**WATERSHED MANAGEMENT PLAN PEER
REVIEW REPORT**

LITTLE JONES CREEK and WILDWOOD
WATERSHEDS
(N919 & Q082, 20TW2940)

Task Work Assignment 20TW0002940

July 2022

Figure 3 – Example Watershed Boundary Peer Review Comments

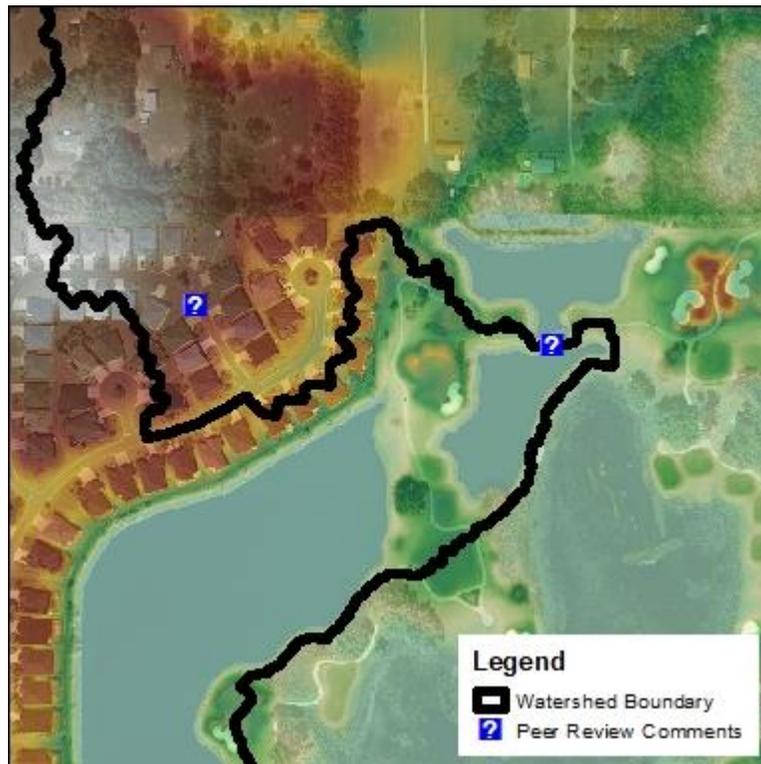
CDM Smith reviewed the Little Jones Creek watershed boundary to confirm that the delineation appeared consistent with flow patterns based on aerial imagery and topography. In general, the watershed boundary is appropriate and only a few instances of potential boundary revisions were noted within the comments geodatabase. **Figure 3** shows two comment locations along the eastern watershed boundary within The Villages. The western comment recommends reviewing whether the remainder of the subdivision should be included within the watershed as it appears there are inlets that collect and convey stormwater runoff to the pond directly south. The comment to the east recommends reviewing whether the waterbody directly north of the comment point should be within the watershed, as it is interconnected with the southern waterbody under a small pedestrian bridge.

Figure 6 – Example Floodplain Peer Review Comment

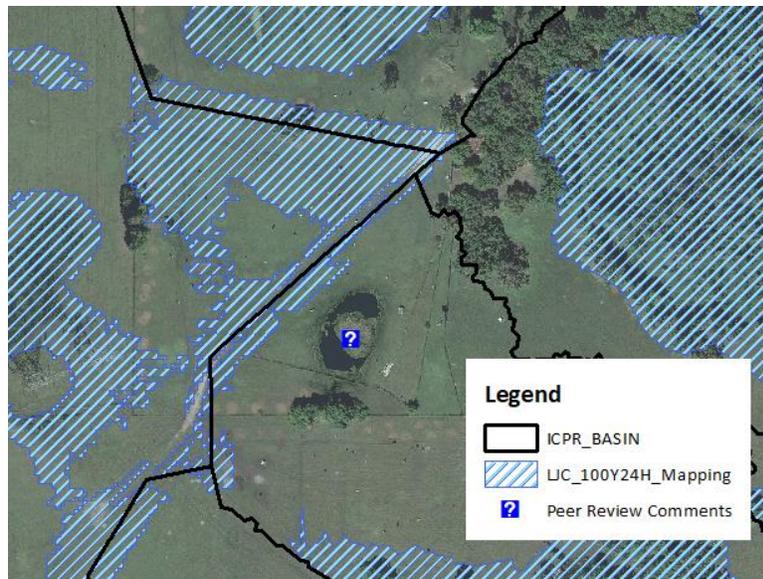
CDM Smith compared the preliminary 100-year/24-hour inundation plots to 2018 aerial imagery and documented flood complaints and known flooding areas within the District’s Historical Water Level geodatabase. The floodplains appeared reasonable and the majority of the known flooding areas are well represented by the preliminary shapes. Comments have been included at six locations where either the aerial imagery shows standing water that is not covered by a preliminary floodplain shape or there is documented flooding without any modeled inundation. Five of these locations were within the Little Jones Creek portion of the watershed and one location was within the City of Wildwood. An example floodplain review comment is included in **Figure 6**.

Figure 7 - 2D Overland Flow Regions

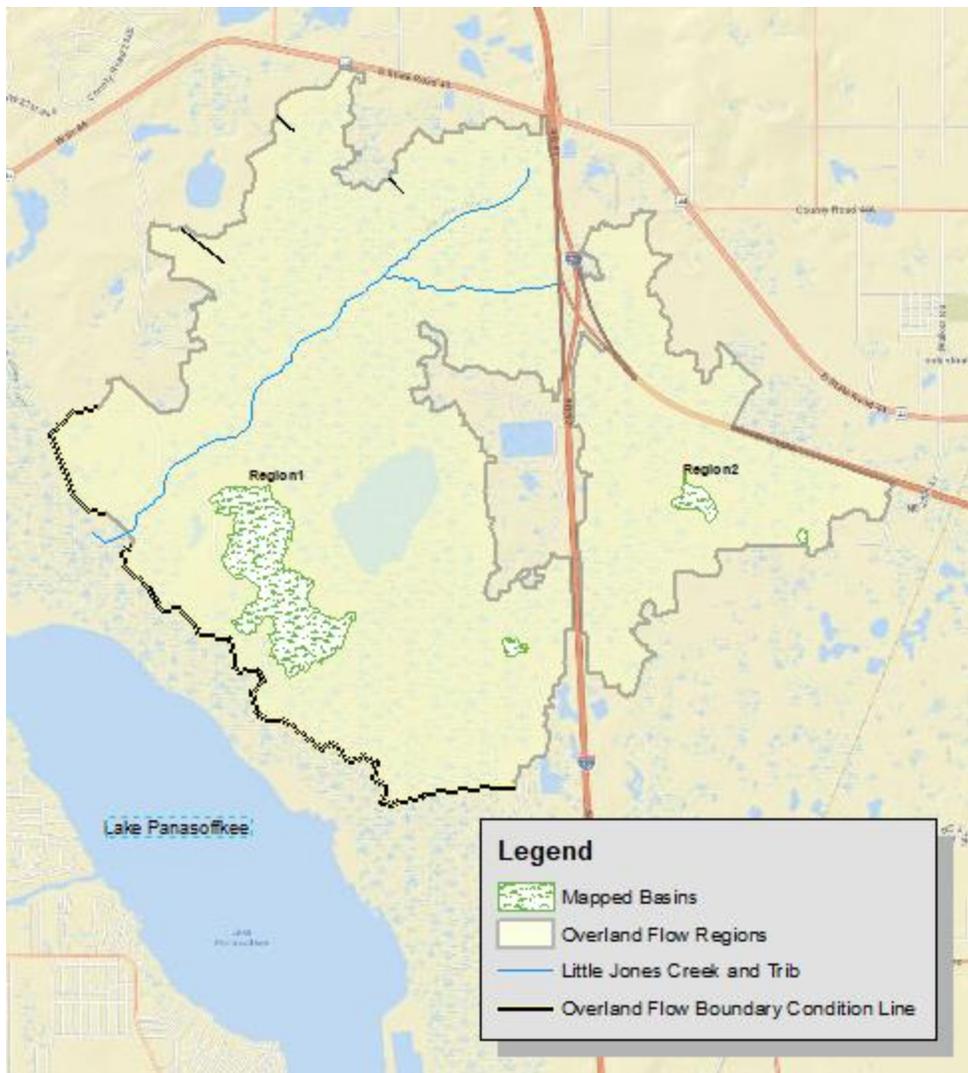
There are two two-dimensional (2D) flow regions included in the western/southwestern portion of the Little Jones Creek/Wildwood model domain. These areas are shown in **Figure 7**. Region 1 is the largest area consisting of approximately 4,910 acres, with two mapped basin regions (approximately 276 acres). Region 1 is the furthest west and includes the Little Jones Creek and borders on Lake Panasoffkee. Region 2 is approximately 1,436 acres, also with two mapped basin regions (approximately 23 acres). Region 2 encompasses the undeveloped area east of Interstate 75 (I-75) in the immediate vicinity of Florida’s Turnpike. The computational grid includes areas of more detailed spacing defined by breaklines, channel representation, and weirs. The grid and associated 2D features seem appropriate in both regions.

Region 1 contains a representation of Little Jones Creek (LJC) which crosses the region in the northern portion running northeast to southwest. LJC is represented in the model with 2D channel control volumes and features. The southwestern edge of the computational grid has a time varying boundary condition line adjacent to Lake Panasoffkee, which specifies the elevation at various points in the simulation. Boundary conditions along the other edges are modeled explicitly using one-dimensional (1D) hydraulic features allowing flow to and from the surrounding manual basin modeled areas. For example, explicitly modeling overland flow weirs connecting the 2D area to the conventionally modeled area, so that calculated runoff can flow to/from the 2D areas as appropriate. There are two regions of mapped basins within Region 1, however based upon a review of aerial photography, it isn't obvious why these areas are included as mapped basins, rather than included in the 2D mesh.

Figure 8 - Example Potential Missing Interconnect

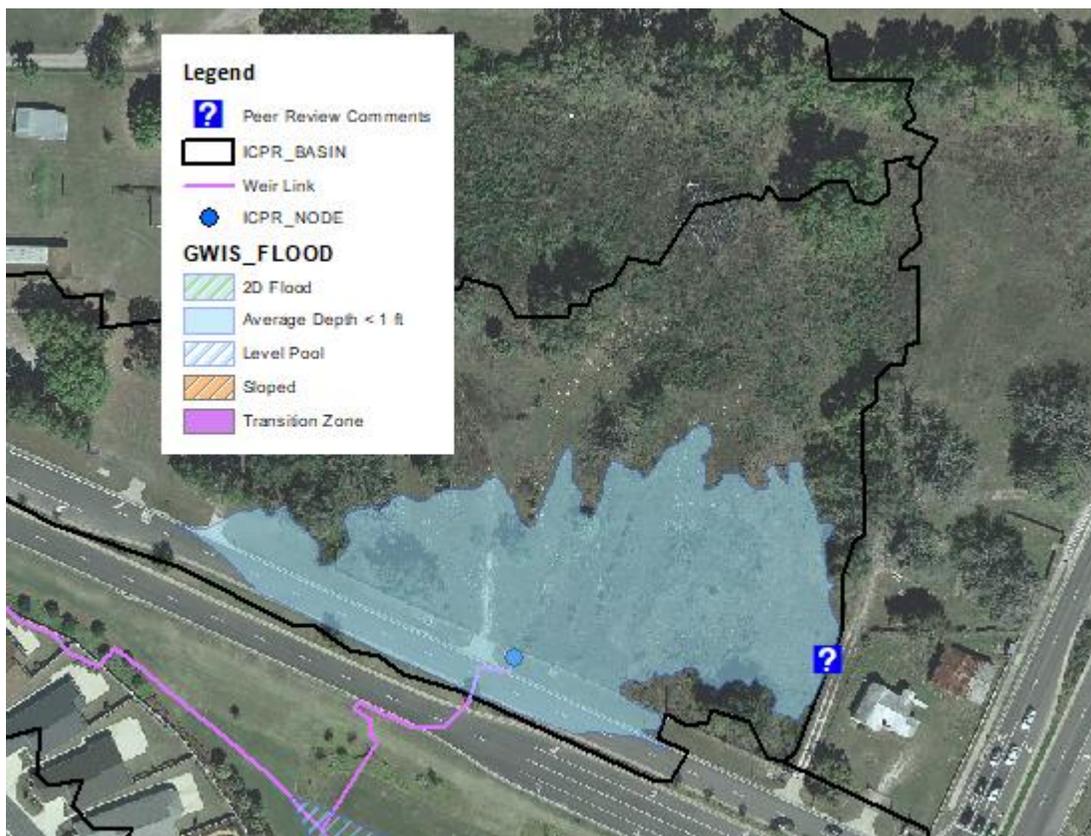
CDM Smith reviewed the floodplain coverage against the basin boundaries for potential missing interconnects, or where the floodplain “glass walls” against the basin boundary without a weir link or channel link to convey the flow. A total of four locations were identified and included in the comments geodatabase. An example is provided in **Figure 8**, where the floodplain abuts the basin boundary (where the peer review comment is located) but there is no weir outfall provided to convey this flow into the neighboring basin.

Figure 9 - FEMA NFHL and GWIS FLOOD Comparison

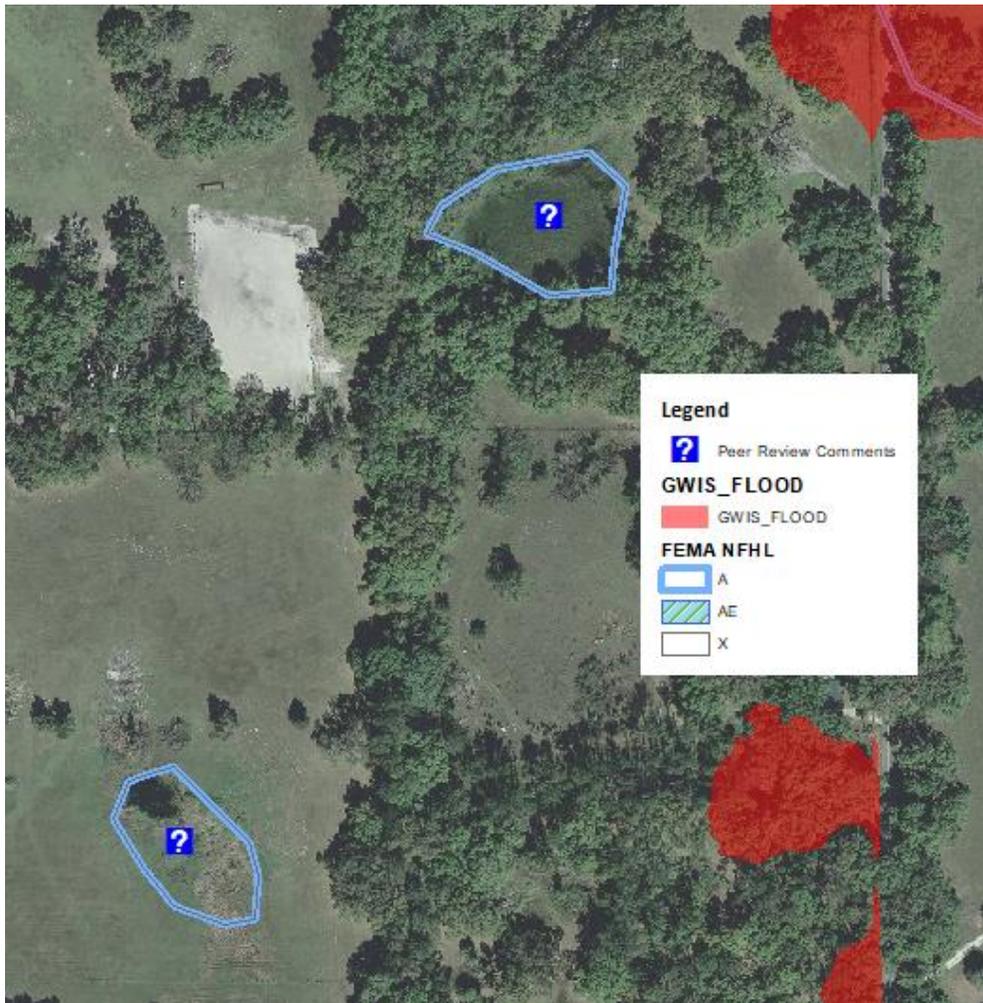
As described within Jones Edmunds’ Floodplain Justification Report, the floodplain feature class developed for this project (GWIS_FLOOD) is significantly more expansive than the current FEMA NFHL coverage within the watershed boundary. Jones Edmunds’ GWIS_FLOOD coverage shows an increase of 1,405 acres, or 2.2 square miles, over the existing FEMA coverage. An increase of this magnitude is expected as the Little Jones Creek watershed model provides an increased level of detail over the 2013 Flood Insurance Study with explicit modeling of stormwater ponds and depressional areas. CDM Smith compared the NFHL coverage to the GWIS_FLOOD coverage in GIS, using both the aerial imagery and the project DEM to note any discrepancies that are not justified. Differences between the NFHL coverage and Jones Edmunds’ floodplain coverage are most frequently attributed to modeling of distinct storage areas, use of newer elevation data, and updates for latest land use and soils data. Only two locations within the watershed were identified for further investigation and have been noted in the comments geodatabase. As shown on **Figure 9**, the locations identified are in the existing FEMA NFHL coverage but are not proposed floodplain shapes within the GWIS_FLOOD feature class. At these locations standing water can be seen from the project aerial imagery.

Figure 10 - BFE Floodplains in Northern Portion of Basin

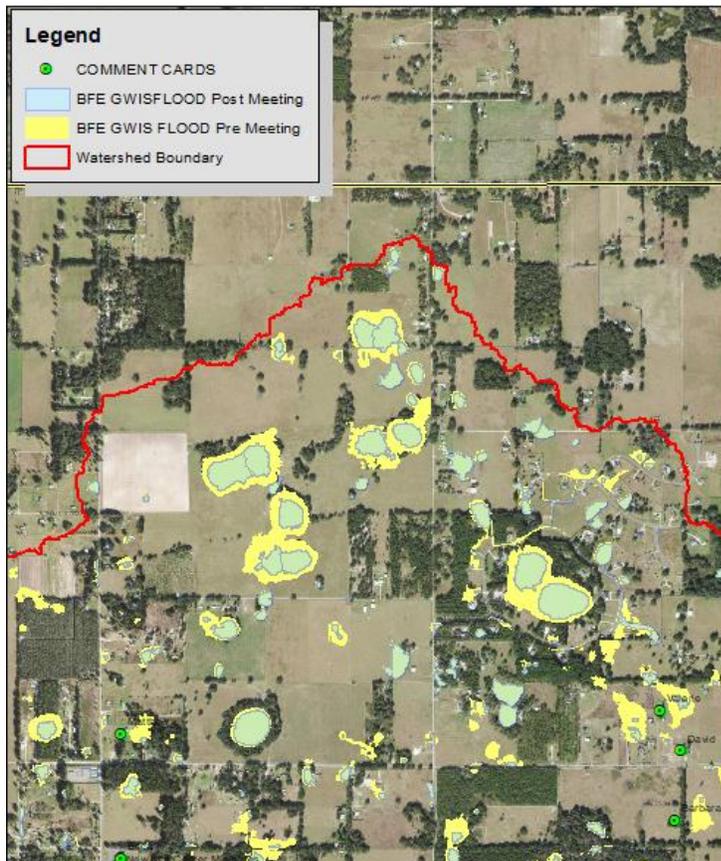
Further, regarding the watershed-wide revisions noted above, the net effect is significant reduction in BFE floodplain extents, in areas that weren't necessarily commented on by the public. For example, in the northern portion of the basin, see **Figure 10**. Previously these

flooded polygons were interconnected, now they are separated. Similarly, the BFE extents are reduced in the 2D floodplain area (**Figure 11**). Please provide the justification to make these hydrological changes basin wide as opposed to locally.

Figure 12 - Irma Floodplains in Northern Portion of Basin

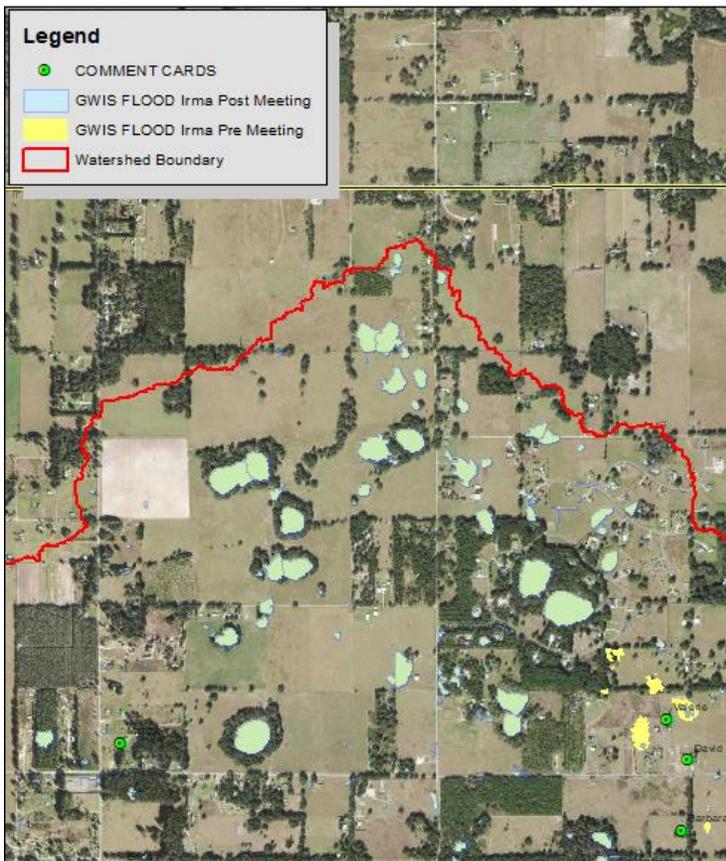
- The reduction in floodplain extents associated with the Irma simulation appear to be more localized to comment areas (i.e., the reduction noted in the BFE ("GWIS_Flood") feature class isn't apparent in the Irma floodplain extent ("GWIS_FLOOD_Irma") as shown in **Figure 12**). Please confirm if the basin wide revisions are included in the calibration model.
- There are several references to basin "LJCC0459" which is included in the model but is not present in the feature class contained in the geodatabase: LJC_GWIS_2.1.2.gdb. Confirm most up to date GWIS data are included.
